Town of Arlington, MA Redevelopment Board

Agenda & Meeting Notice November 7, 2022

3. Public Hearing Docket #3717 80 Broadway

Public Hearing Docket #3722 141 Massachusetts Avenue

3 SPRING 3PM

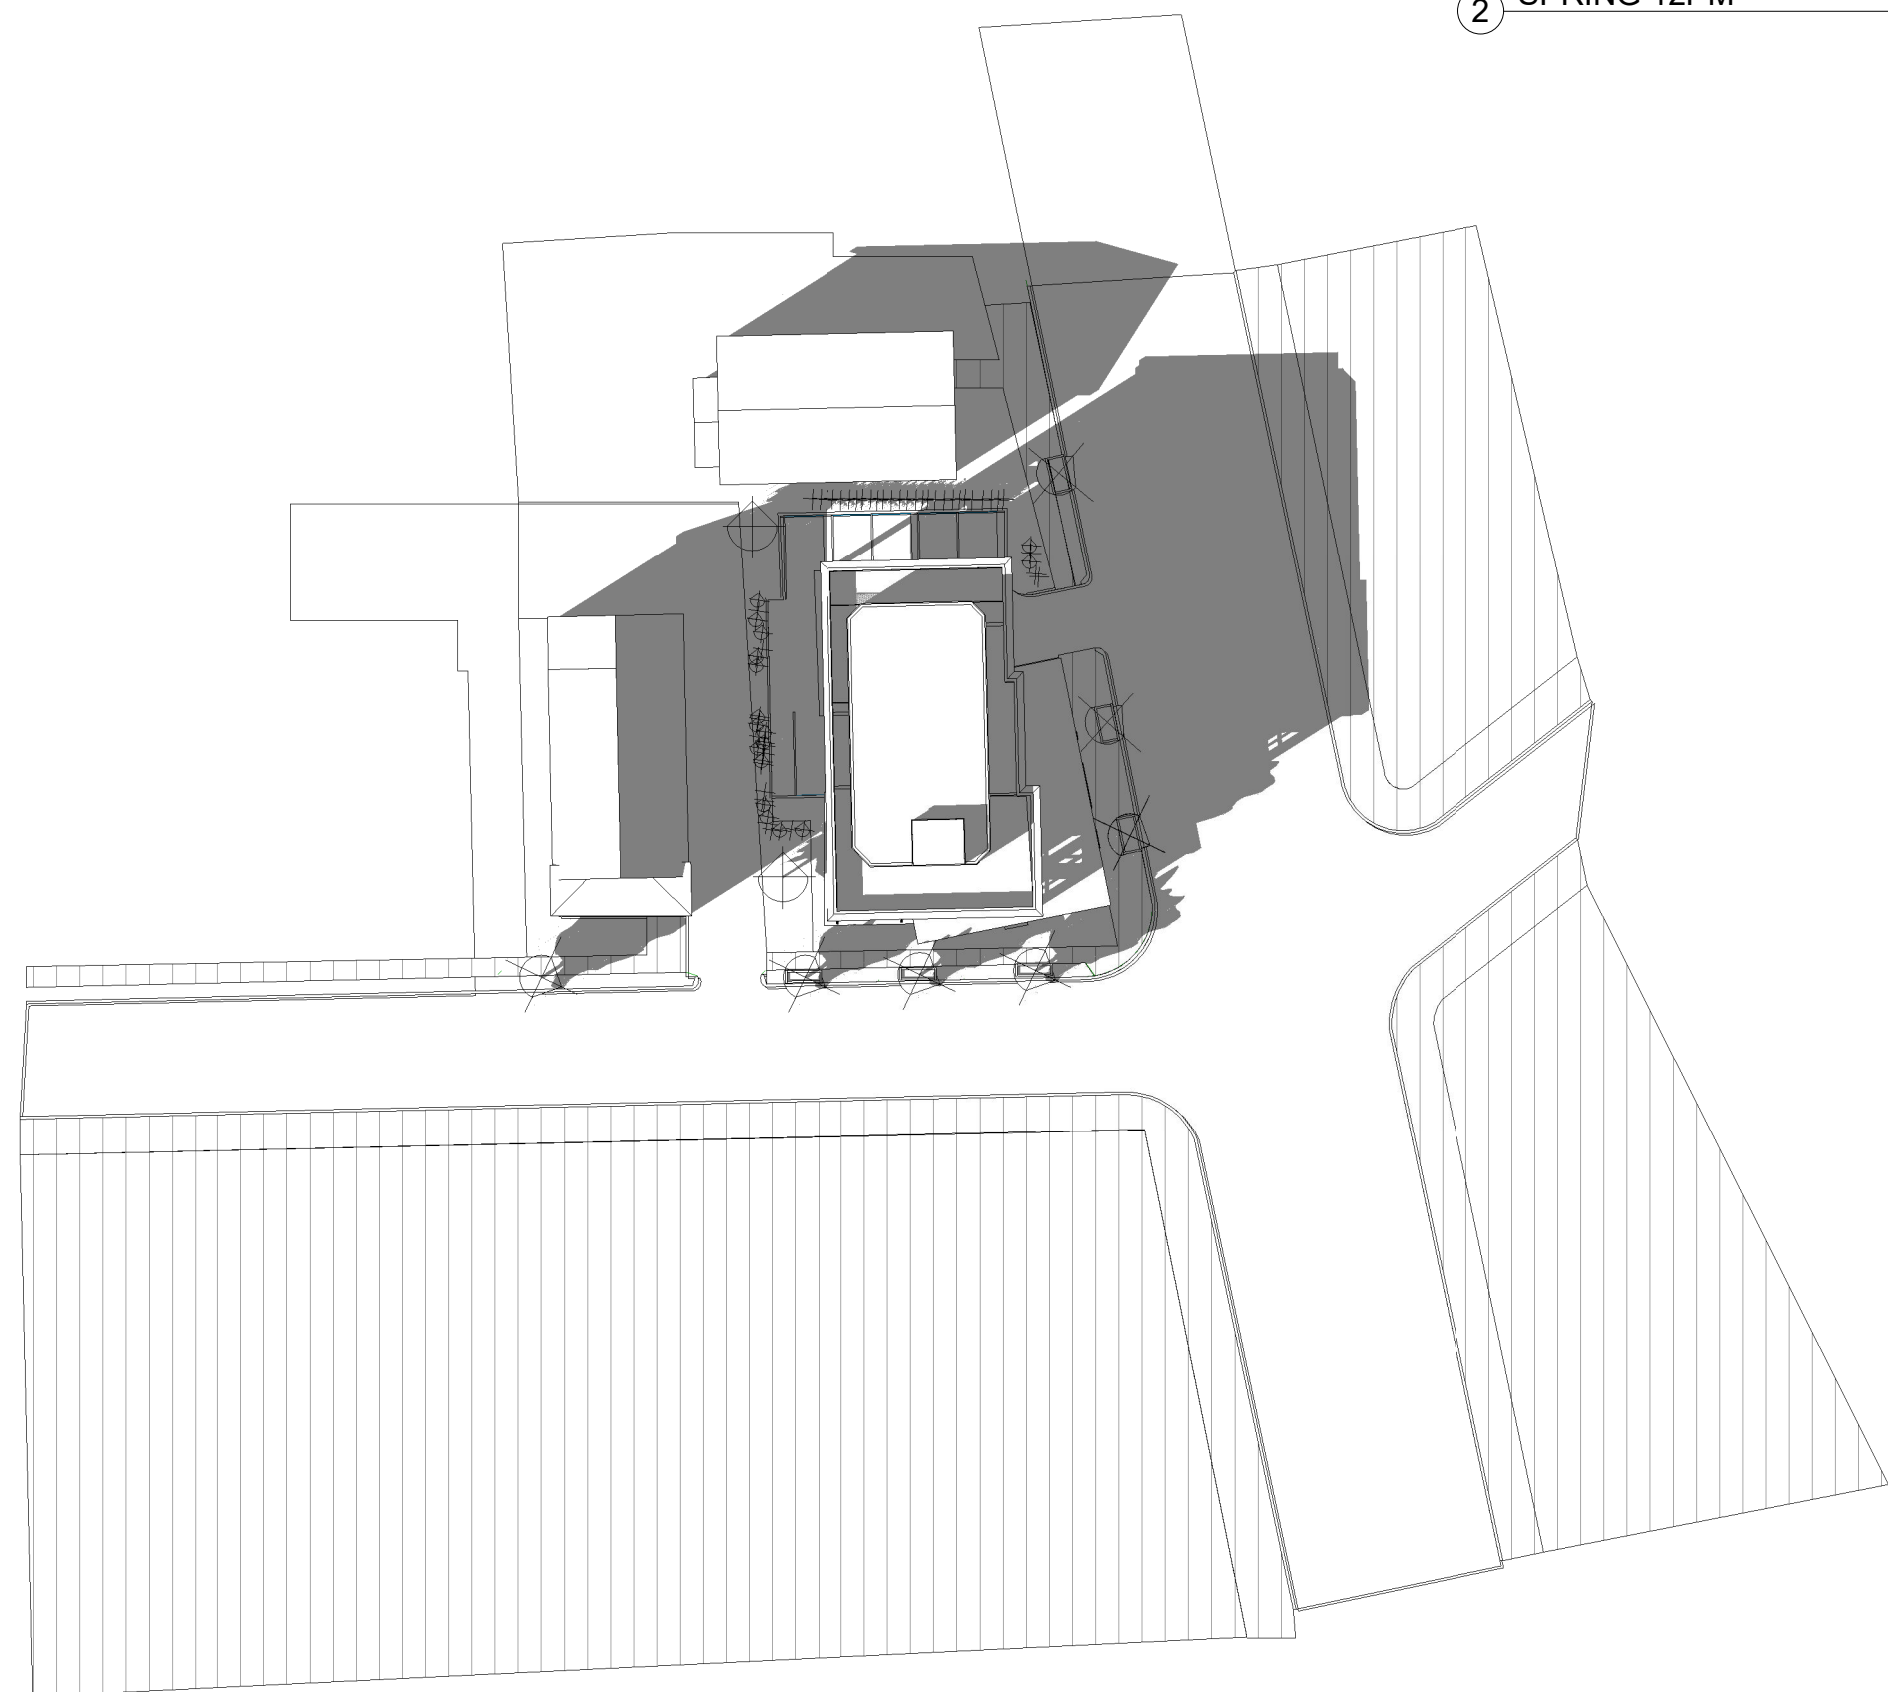
5. Could the applicant provide the Board with corrected and more detailed solar impact drawings A2.10 - A2.13? These drawings incorrectly show Broadway as running North to South, more than 60° off from reality. These drawings omit any detail of the affected properties, notably the array of solar panels on the roof of 88 Broadway.
